#### Sixty-fifth session

**Collective amendments—Regulations Nos. 19, 48,  
98, 99, 113 and 123**

### **Proposal for the [06] series of amendments to Regulation Nos. 48 (Installation of lighting and light-signalling devices)**

#### **Submitted by the experts from the Netherlands and Germany\***

Model A

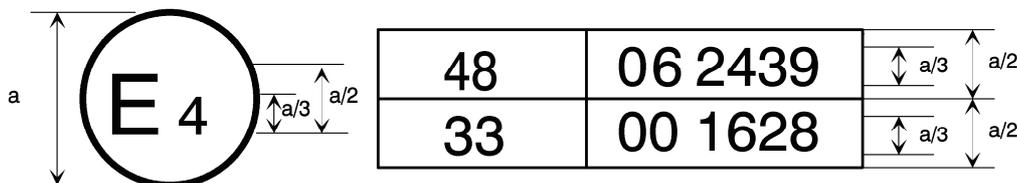
The above ... Regulation No. 48 as amended by the [06] series of amendments. The approval number indicates that the approval was granted in accordance with the requirements of Regulation No. 48 as amended by the [06] series of amendments.
